Office Action Summary	Application No. 10/660,438	Applicant(s) KOVACEVIC, BRANKO D.	
	Examiner Bryan P. Bui	Art Unit 2153

DETAILED ACTION

1. This following office action is responsive to Application No. 10/660438 filed on 09/11/2003, having claims 1-45 and Figures 1-11.
2. Applicant's preliminary amendment filed on 10/28/2004 to add the Cross-Reference to Related Applications to the specification has been received and entered into the record.

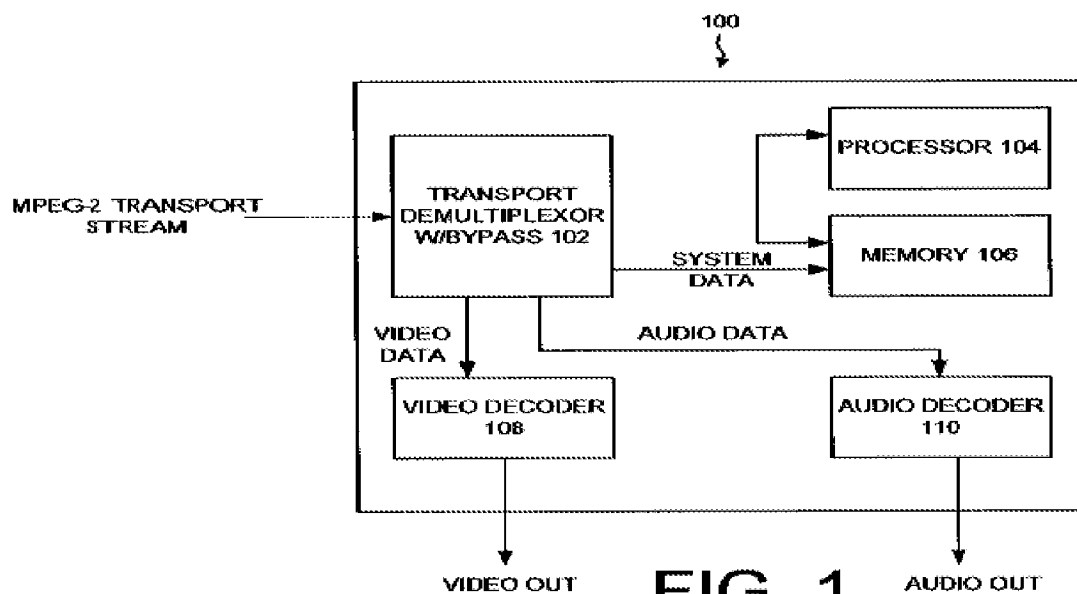
Regarding claim 1, Anderson teaches a method [**an improved receiver that can receive and process many different data types in addition to decoding MPEG-2 transport stream**] (col. 2, lines 19-21) comprising the steps of:

receiving a first data stream of multimedia data, wherein the multimedia data includes a first protocol and further wherein the first protocol is unknown (see col. 7, lines 17-20);

determining, based upon a first portion of the first data stream, the first protocol of the multimedia data (see col. 7, lines 21-33 together with Fig. 1&2: **Transport Demultiplexor W/BYPASS 102**)

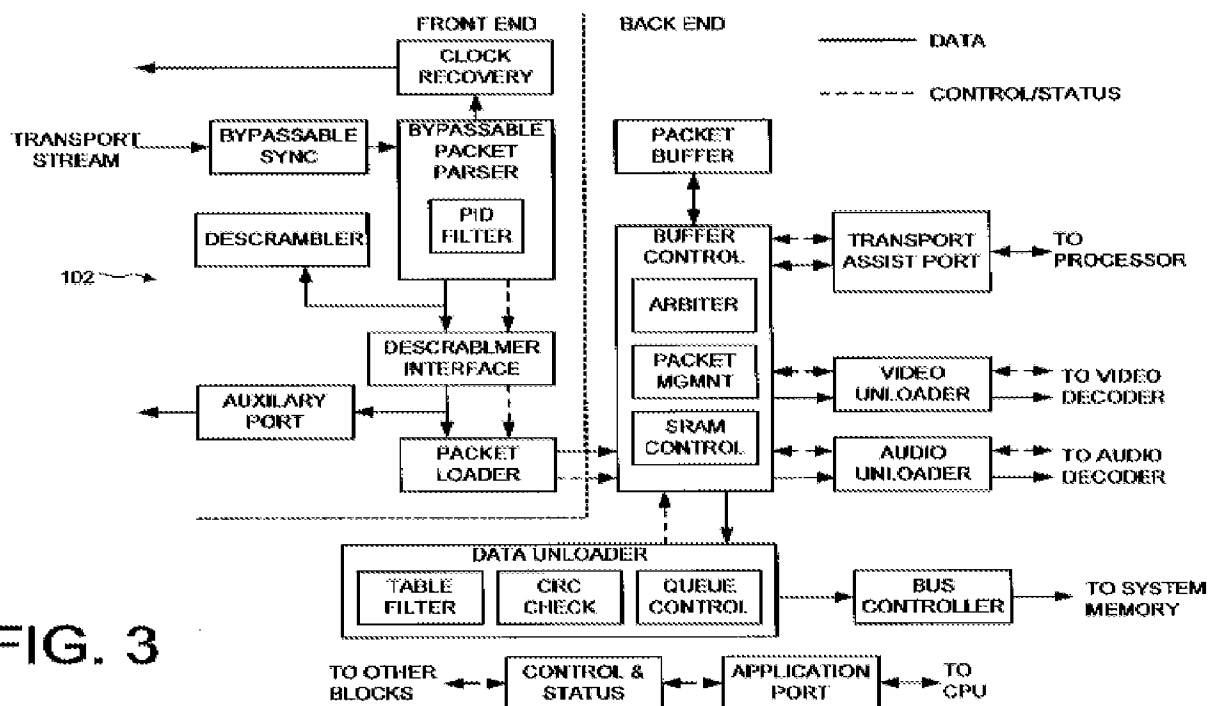
Regarding claim 2, Anderson discloses “the first protocol is one of a set of predefined protocols comprising MPEG-2, Direct TV, and DVD protocols” (**MPEG-2 and non-MPEG-2 transport streams** and col.2 , lines 21-24).

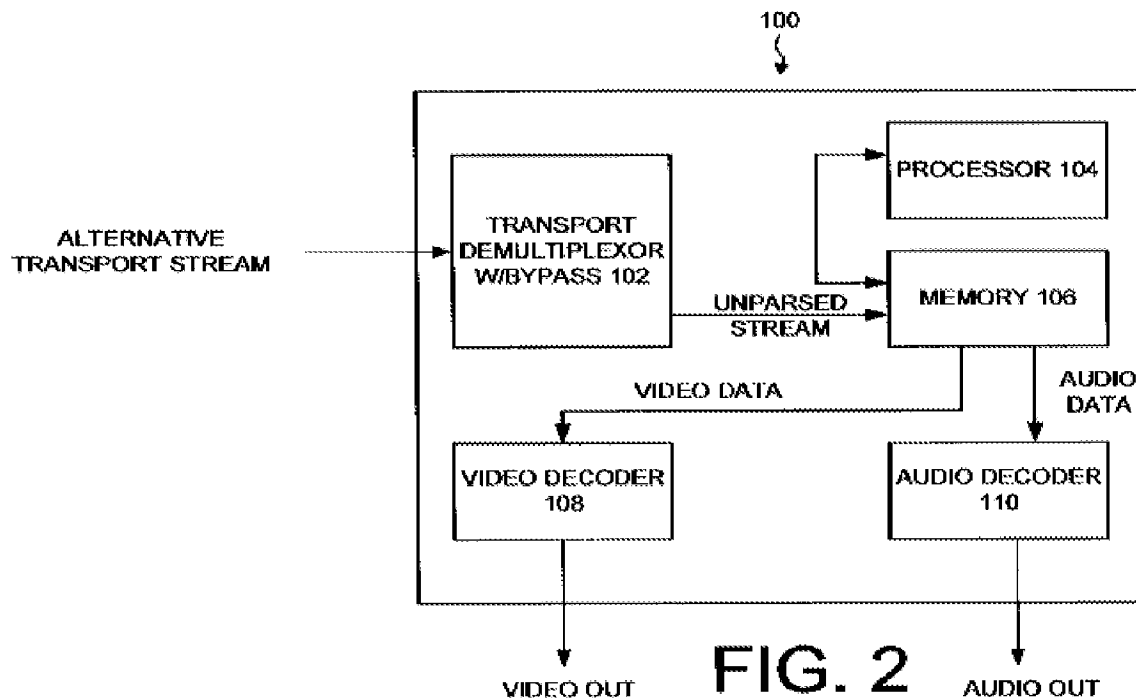
Regarding claim 14, Anderson discloses the claimed features “receiving a second data stream of multimedia data, different from the first data stream, wherein the multimedia data of the second data stream includes a second protocol, different from the first protocol and further wherein the second protocol is unknown” and “determining, based upon a first portion of the second data stream, the second protocol of the multimedia data of the second data stream” (see col. 8, lines 6-22 and Fig. 2: Alternative Transport Stream).
